Access Compliance Report Public Rights-of-Way (Curb Ramps)

Main Street: N/A Cross Street: HARBOR_BLV Location: S

ADA ID: RPRK220222165718 Ramp Type: Type 7 - Directional 2 Initial Pass/Fail: Pass Overall Compliance: No Severity Score: 12

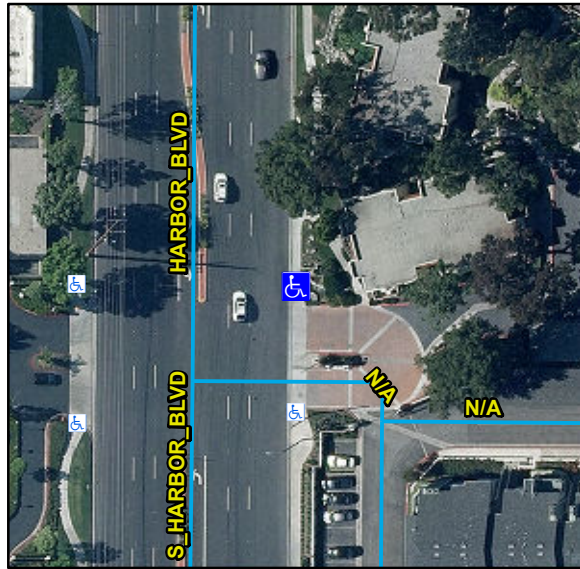
Compliance	Description	Data	Compliance	Description	Data
N/A	Ramp Length (in)	112	N/A	Flare Type LT	
Yes	Ramp Width (in)	49			None
Yes	Ramp Run Slope (%)	6.3	N/A	Flare Slope LT (%)	N/A
Yes	Ramp Cross Slope (%)	1.7	N/A	Flare Traversable LT	N/A
Yes	Grade Break	Yes	Yes	Flare Type RT	
Yes	Grade Break Slope (%)	5			Curbed2
No	Grade Break Cross Slope (%)	5.2	N/A	Flare Slope RT (%)	N/A
	Addl Para Ramp Left?	No	N/A	Flare Traversable RT	N/A
	Addl Para Ramp Right?	No	Yes	DWS Provided	Yes
N/A	Landing Present	Yes	Yes	DWS Contrast	Yes
Yes	Landing Length (in)	117	Yes	DWS Length (in)	24
Yes	Landing Width (in)	53	No	DWS Full Width	No
Yes	Landing Run Slope (%)	0.3		DWS Offset Type	Multiple
No	Landing Cross Slope (%)	4.4	Yes	DWS Left Offset (in)	0
N/A	Landing Movement Obstructed?	No	No	DWS Right Offset (in)	65
	Landing Movement Type	N/A			
N/A	Landing Shared	No			
N/A	Marked Crosswalk 1	No	N/A	Clear Space	N/A
	Crossing 1 Direction	S	N/A	Clear Space To Crosswalk (in)	N/A

Marked Crosswalk 1 Width (in)	N/A			
N/A	Ramp Inside Crosswalk 1	N/A			
	Crossing 1 Slope (%)	11.1			
	Crossing 1 Cross Slope (%)	0.9			
Yes	Gutter Ponding	No	Yes	Curb Slope	1.6
Yes	Gutter Lip Height (in)	0		Road Run Slope (%)	N/A
No	Gutter Run Slope (%)	9.9		Road Cross Slope (%)	N/A
No	Gutter Cross Slope (%)	6.5		Parallel Ramp Side	Right
Yes	Overall Surface Condition	Acceptable	Yes	Perp Joint Present	Yes
	Cross Gutter Present?	Yes		Spandrel Present?	Yes
	Replace Cross Gutter?	No		Replace Spandrel?	No

Remove & Replace Entire Ramp. Remove & Replace Gutter.

R304.5.3, R305.1.4, R305.2, R304.5.4, STD 1115
